SUBJECT: AMENDMENT NO. 19 TO FACILITY OPERATING LICENSE NPF-86: REACTOR COOLANT SYSTEM PRESSURE/TEMPERATURE LIMITS - LICENSE AMENDMENT REQUEST 92-06 (TAC M84344)

SEABROOK STATION, UNIT NO. 1

Amendment No.19
License No. NPF-86

RELATED TO AMENDMENT NO. 19 TO FACILITY OPERATING LICENSE NO. NPF-86

FIGURE 3.4-2

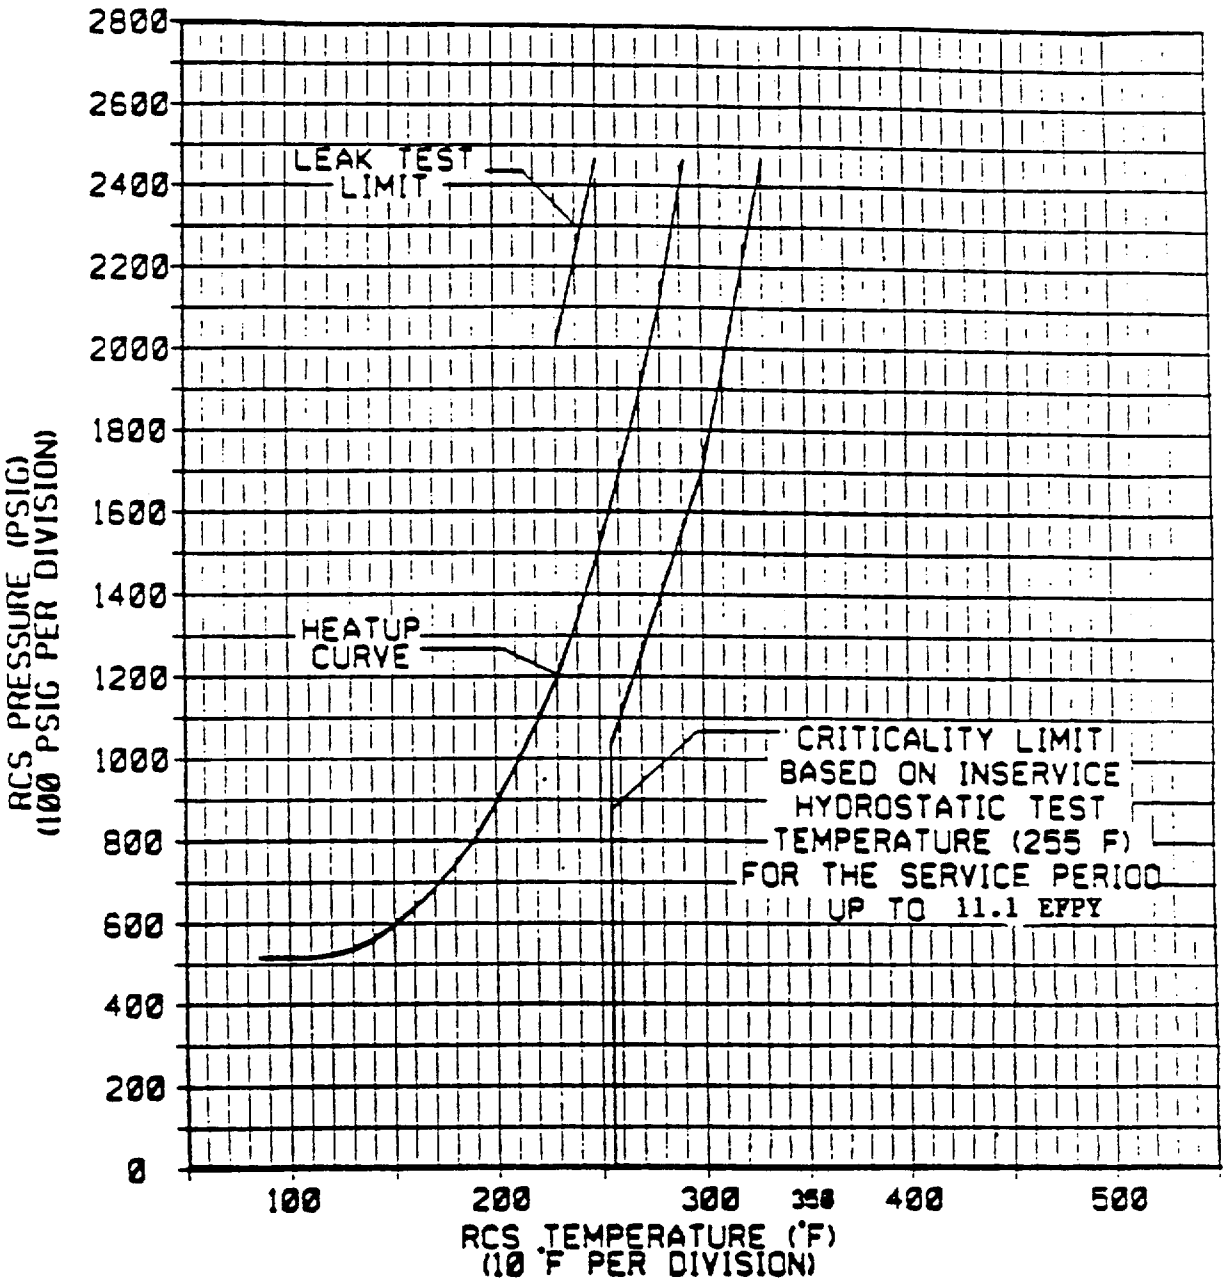
The amendment revises the Appendix A Technical Specifications (TSs) relating to Reactor Coolant System heatup and cooldown limitations. Specifically, Figures 3.4-2 and 3.4-3 are modified to show applicability of the curves up to 11.1 equavalent full-power years (EFPY), to provide revised RT_{NDT} values at 11.1 EFPY at 1/4 and 3/4 thickness, and to indicate the copper content of the controlling material. These changes implement commitments made by North Atlantic Energy Corporation (letter G. Thomas to USNRC dated November 30, 1988) in response to Generic Letter 88-11.

The amendment revises the Appendix A Technical Specifications (TSs) relating to Reactor Coolant System heatup and cooldown limitations. Specifically, Figures 3.4-2 and 3.4-3 are modified to show applicability of the curves up to 11.1 equavalent full-power years (EFPY), to provide revised RT_{NDT} values at 11.1 EFPY at 1/4 and 3/4 thickness, and to indicate the copper content of the controlling material. These changes implement commitments made by North Atlantic Energy Corporation (letter G. Thomas to USNRC dated November 30, 1988) in response to Generic Letter 88-11.

Controlling material:	Base metal
Copper content:	0.06 WT%
RT_{NDT} initial:	40°F
RT_{NDT} after 11.1 EFPY:	1/4T, 108°F
	3/4T, 86°F

Curve applicable for heatup rates up to 60°F/hr for the service period up to 11.1 EFPY and contains margins of 10°F and 60 psig for possible instrument errors
